The funicular planning application (3) â?? how can it be valid when access tracks omitted?

This post takes a look at the scope of Highlands and Islands Enterprise's planning application ([see here for papers](#)) to repair the funicular, its proposals for accessing the areas where they say work is required and the impact that this will have on the natural environment.

Fig 3 – Mid-compound layout utilising existing shieling for welfare  
(Extract from Drg no CS19035C007-T)

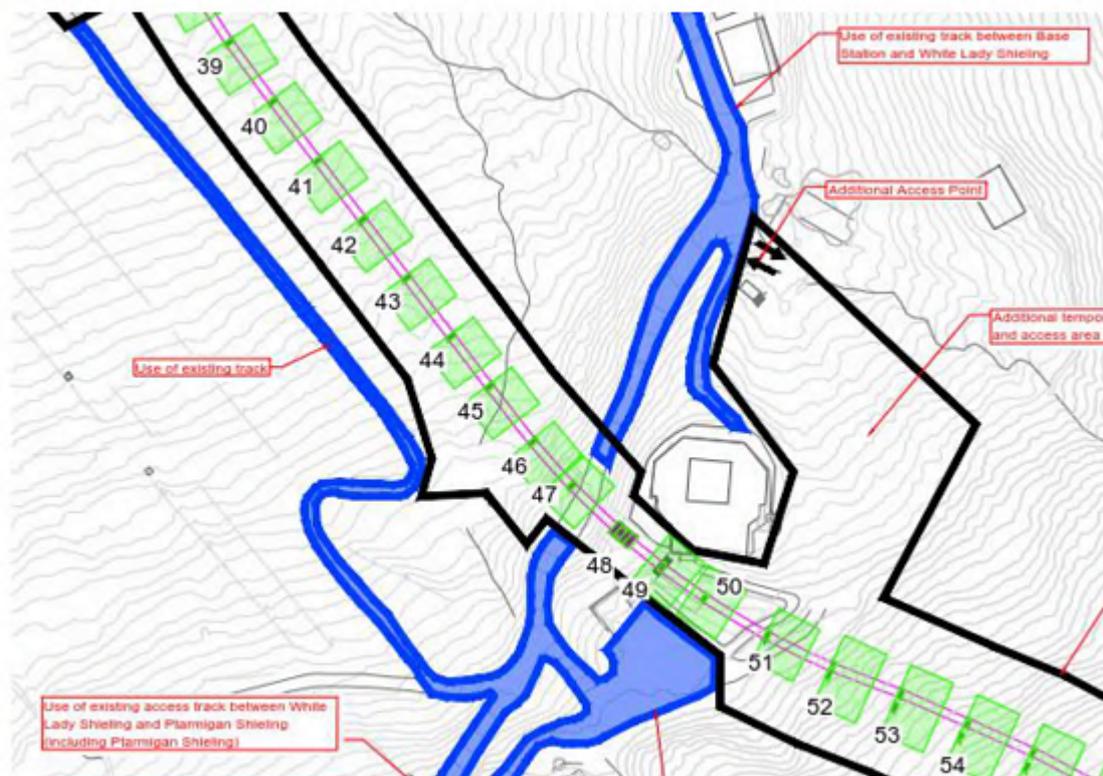
Extract from site plans for area around the Shieling. The green blocks the areas that HIE claims require planning permission, the black line the boundary that HIE says will be affected by the works and the blue access tracks. The Shieling tow access track is the blue line on the left.

The working area where vegetation and soils may be affected and machinery may be driven is clearly much larger than the 0.98 hectares around the pillars included in the Planning Application.

What's more, besides the area marked in black, the application states that *existing access tracks will be heavily used and upgraded where necessary and maintained in the current condition* and that *additional temporary tracks* will be constructed to connect the existing access tracks to the working area. To take the example of the Shieling track:

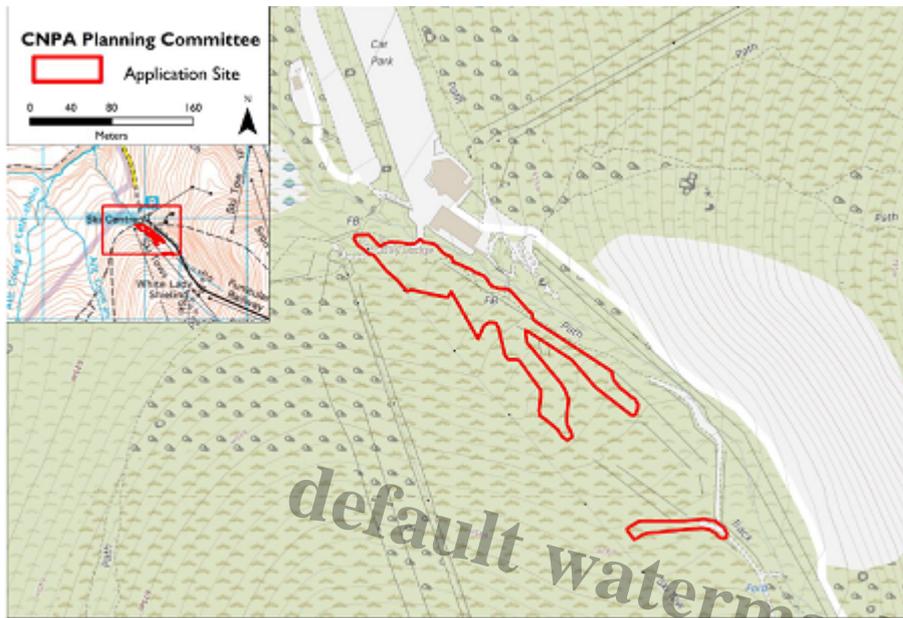
What this means is that HIE is claiming that they don't need planning permission either to upgrade the Shieling track or to install three new temporary tracks to connect it to the working area.
